Access Compliance Report

Public Rights-of-Way

(Curb Ramps)

Intersection ID: 3731	Main Street: HARRIS_CORNERS_PY	Cross Street: HARRIS_OAKS_BV	Location: NW
ADA ID: 7676A6431C46	Ramp Type: Perp	Initial Pass/Fail: Fail	Overall Compliance: No
Codes/Mitigation Info/Possible Solution		Field Measurements/Component Compliance

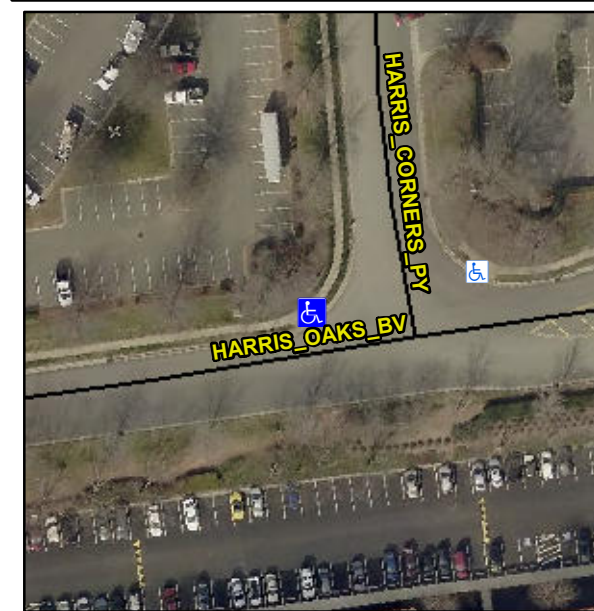
R304.5.1, R304.5.3

Compliance	Description	Data	Compliance	Description	Data
N/A	Ramp Length (in)	52.0	Yes	Ramp Slope (%)	8.3
No	Ramp Width (in)	47.0	No	Ramp XSlope (%)	4.3
N/A	Flare Type LT	N/A	N/A	Flare Type RT	N/A
N/A	Flare Slope LT (%)	N/A	N/A	Flare Slope RT (%)	N/A
N/A	Flare Traversable LT?	N/A	N/A	Flare Traversable RT?	N/A
N/A	Landing Length (in)	N/A	N/A	DWS Provided?	N/A
N/A	Landing Width (in)	N/A	N/A	DWS Contrast?	N/A
N/A	Landing Slope (%)	N/A	N/A	DWS Length (in)	N/A
N/A	Landing X Slope (%)	N/A	N/A	DWS Full Width?	N/A
N/A	Landing Curb? (Y/N)	N/A	N/A	DWS Offset (in)	N/A
N/A	Shared Landing?	N/A			
N/A	Gutter Ponding?	N/A	N/A	Gutter Slope (%)	N/A
N/A	Gutter Lip Ht (in)	N/A	N/A	Gutter X Slope (%)	N/A
N/A	Painted X Walk1?	No	N/A	Painted X Walk2?	N/A
	X Walk 1 Direction	To NE		X Walk 2 Direction	N/A
N/A	X Walk 1 Width (in)	N/A	N/A	X Walk 2 Width (in)	N/A
	X Walk 1 Slope (%)	3.5		X Walk 2 Slope (%)	N/A
	X Walk 1 X Slope (%)	4.5		X Walk 2 X Slope (%)	N/A

Remove & Replace Entire Ramp.
